Subject: Oyster Creek Nuclear Generating Station (OCNGS)
Operating License No. DPR-16
Docket No. 50-219
Response To Additional Information
Concerning In-Structure Response Spectra

GPU NUCLEAR RESPONSES TO ADDITIONAL INFORMATION

REGARDING IN-STRUCTURE RESPONSE SPECTRA

Figure 1s1-1: Deconvolved Motion, 3 Soil Conditions vs. 60% of Ground Surface Target, OCNCS Reactor Building

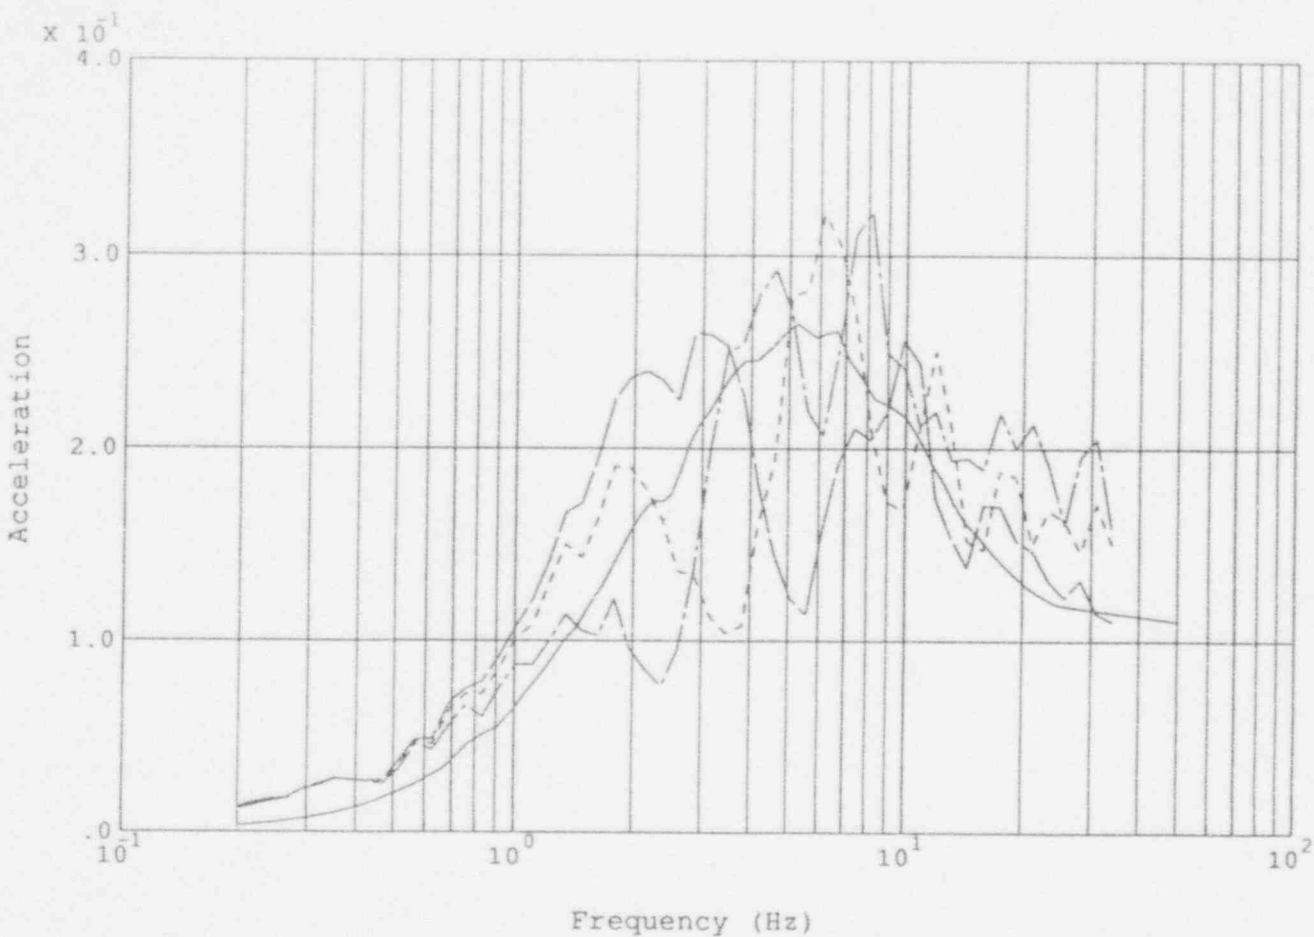
Provide the three sets of spectra (corresponding to the three high-strain soil profiles) developed at the foundation level together with the enveloping spectra and 60% of the site specific response spectra (SSRS). Also, provide modified synthetic time-histories (if any) developed to ensure that the 60% criterion is satisfied.

1. The deconvolved spectra for the two horizontal time histories developed at the foundation level for the three high strain soil profiles and the time histories to be used in the final analyses are shown in Figures 1s1-1 and 1s1-2. The envelope of the three spectra for each of the horizontal directions are shown in Figures 1-1 and 1-2. These figures show the comparison of both horizontal components to 60% of the surface spectrum. The spectra from these time histories meet the 60% requirement at all frequencies. These time histories are included in the diskette as part of the response to Question 4.

STAR TRUSS

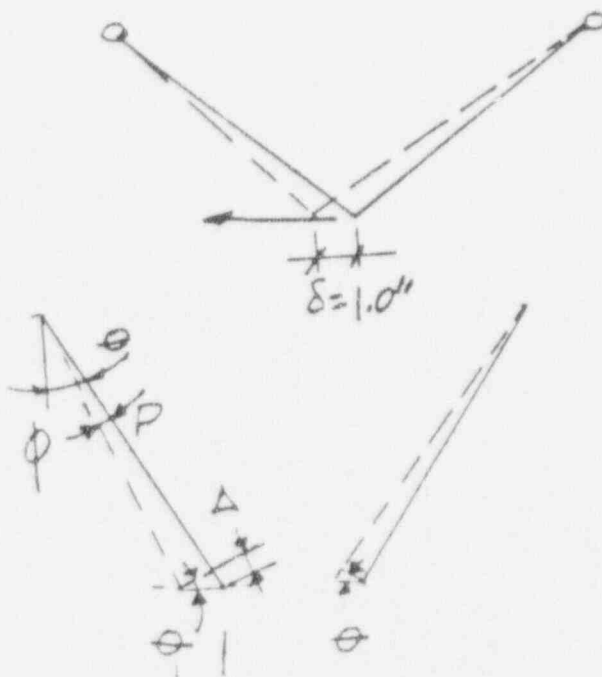
1. ERROR IN AREA OF LEGS
2. QUESTION ON LOCAL RADIAL STIFFNESS OF DRYWELL VESSEL

THIS IS ABOUT $\frac{1}{3}$ THAT CALCULATED

IN REALITY, THE SPRING CONSTANT OF THE STAR TRUSS IS IN BETWEEN BLUME'S VALUE (690,081 KIPS/FT) AND GH'S VALUE (222,360 KIPS/FT). CONSIDERING THAT THE USE OF A LOWER SPRING CONSTANT WILL TEND TO LOWER THE CALCULATED NATURAL FREQUENCY OF

THEREFORE, GH'S APPROACH TO EVALUATE THE RIGIDITY OF THE STAR TRUSS IS CONSERVATIVE.

RPV STABILIZER - NO URS/BLUME CALC.

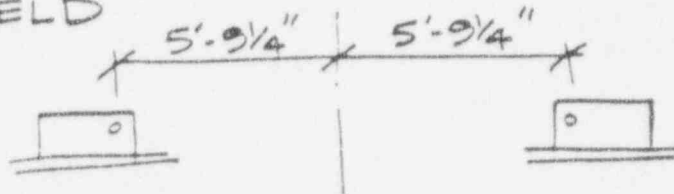
WHILE THE ABOVE ROUGH CHECK IS $\sim 1/4$ OF URS/BLUME VALUE, THE BLUME VALUE IS REASONABLE IF A MORE PRECISE ANALYSIS WERE PERFORMED CONSIDERING GLEEVES, SPRINGS, 10" ϕ PIPE IN THE WHOLE ASSEMBLY

$$\therefore K = 53,000 \text{ KIPS/FT} \sim 48,000 \text{ KIPS/FT}$$

THEREFORE, USE OF 48,000 KIPS/FT FOR
Rx STABILIZER SPRING CONSTANT IS REASONABLE.

FIG. 2s1-1

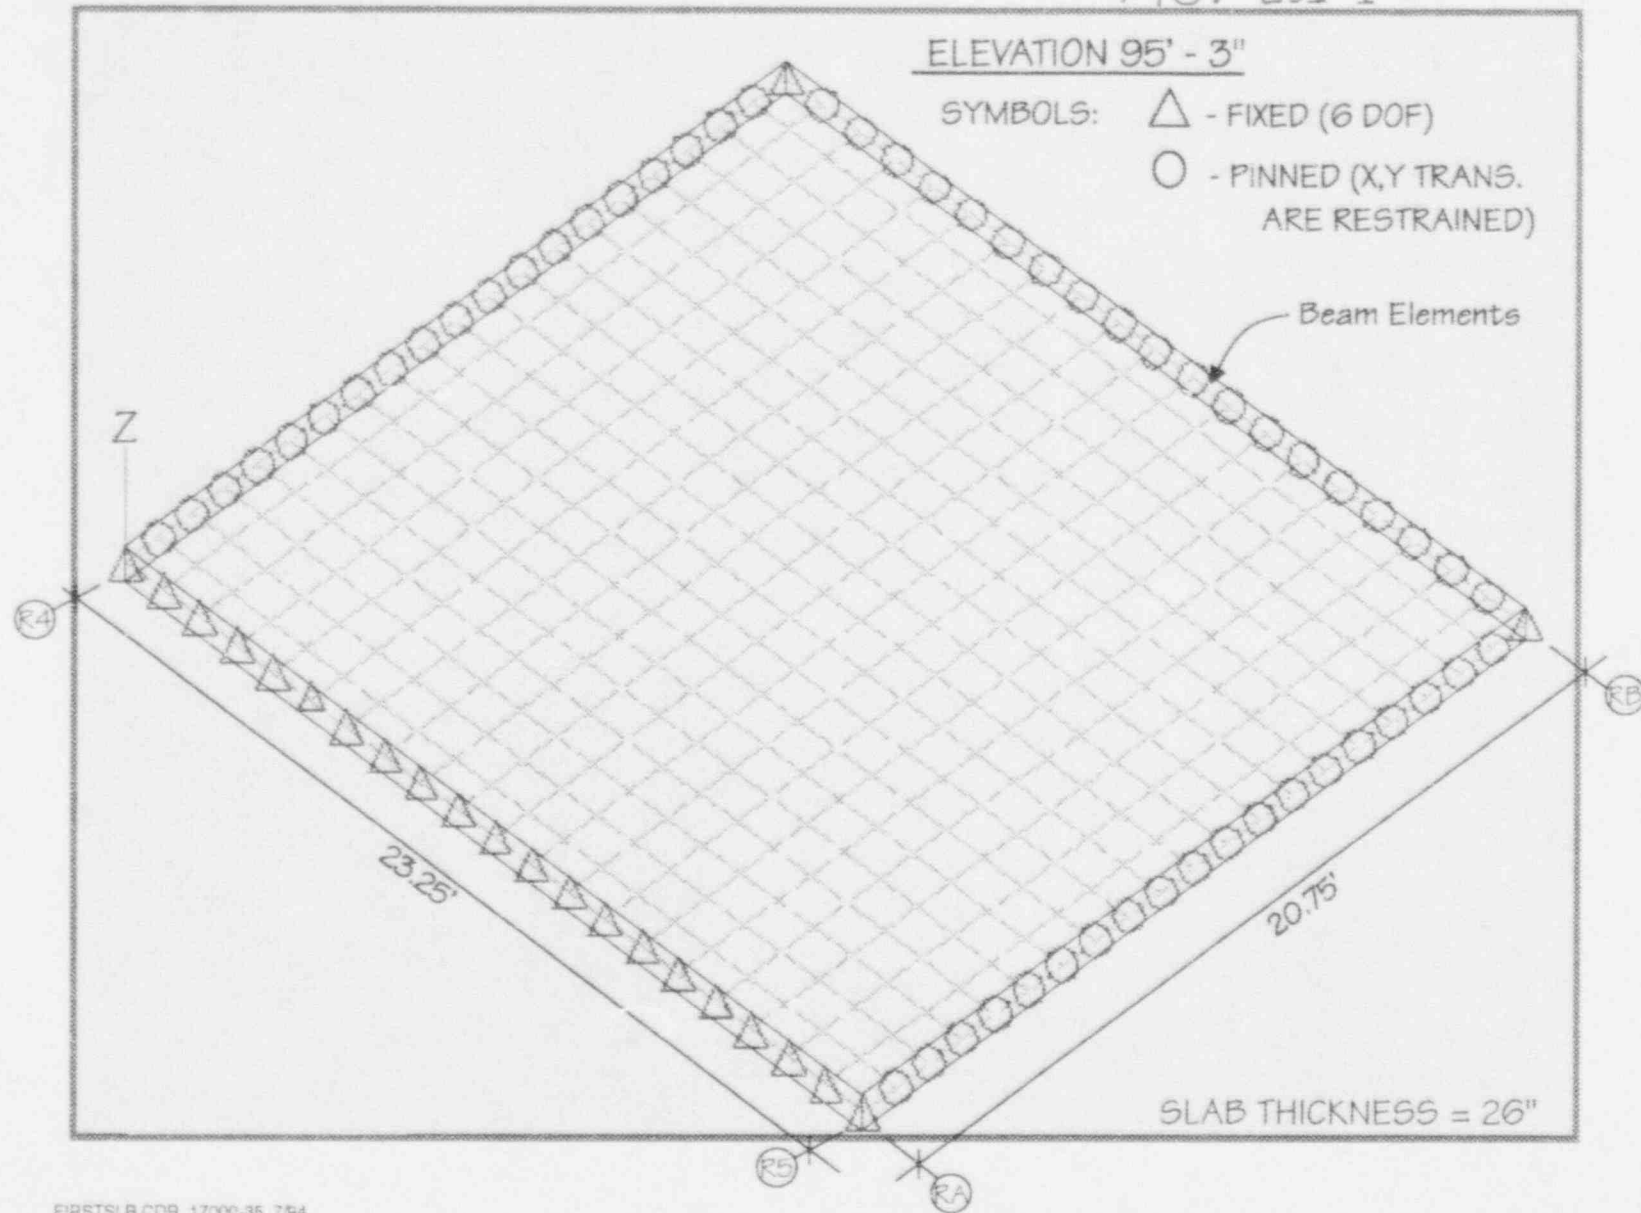
- 2.c A number of floor slabs and walls at OCNGS have been identified as vertically flexible. Provide information related to the plans for developing vertical floor response spectra for these floors.

The first slab selected is at elevation 95'-3" between column lines RA, RB, R4, and R5. Its plan dimensions are 23.25' by 20.75' and its thickness is 26". At line RA, the slab is connected to a wall and is supported by beams at the other lines and by columns at the corners. The modal analysis of this slab predicts a fundamental vertical frequency of 43.5 Hz.
